Well Name: CORRAL BLUFF 11_14 FEDERAL COM	Well Location: T25S / R29E / SEC 2 / SWSW / 32.153547 / -103.961651	County or Parish/State: EDDY / NM
Well Number: 31H	Type of Well: OIL WELL	Allottee or Tribe Name:
Lease Number: NMNM15303	Unit or CA Name:	Unit or CA Number:
US Well Number: 3001548021	Well Status: Drilling Well	Operator: OXY USA INCORPORATED

Subsequent Report

Type of Action: Temporary Abandonment

Conditions of Approval for Temporary Abandonment of Wells

FINAL TA WELLBORE

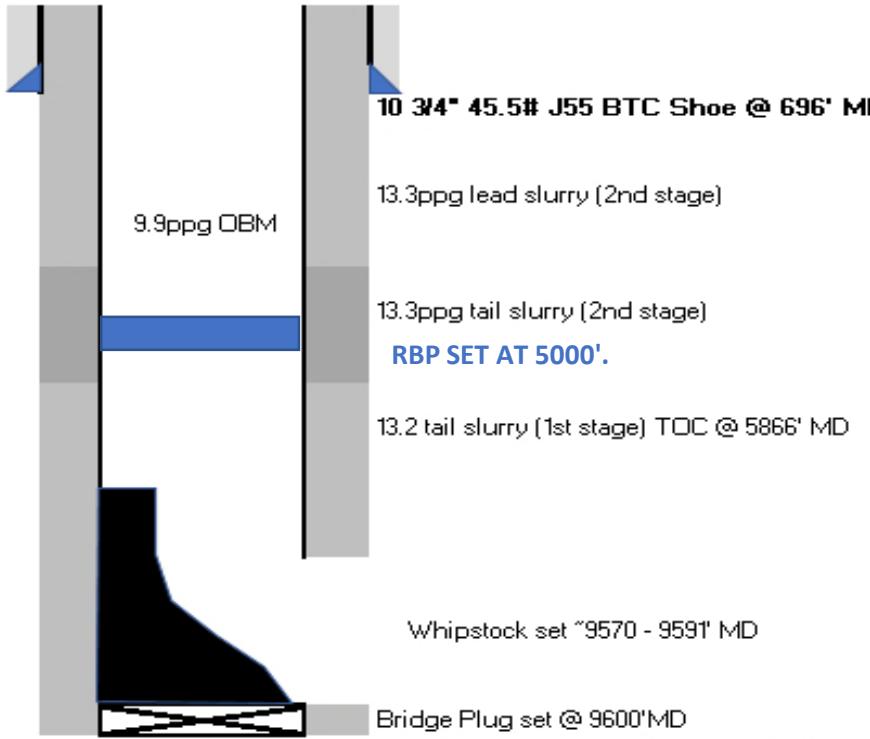
1. TA status will be effective for a period of up to one year from the date of sundry approval and can be renewed annually thereafter per IM NM-2016-017.
2. A bridge plug (CIBP) must be installed 50 to 100 feet above any open perforations or open hole. The CIBP must be capped with either a minimum of 25 sacks of cement if placed with tubing or 35 feet of cement if placed with a bailer. The top of the cement must be verified by tagging. **Operator has set a retrievable bridge plug @ 5000'.**

BLM Note: COA requirements for TA has not been met for approval. TA status with the well as-is only valid for 90 days. Operator to update BLM with go forward plans for this well within 90 days of approval
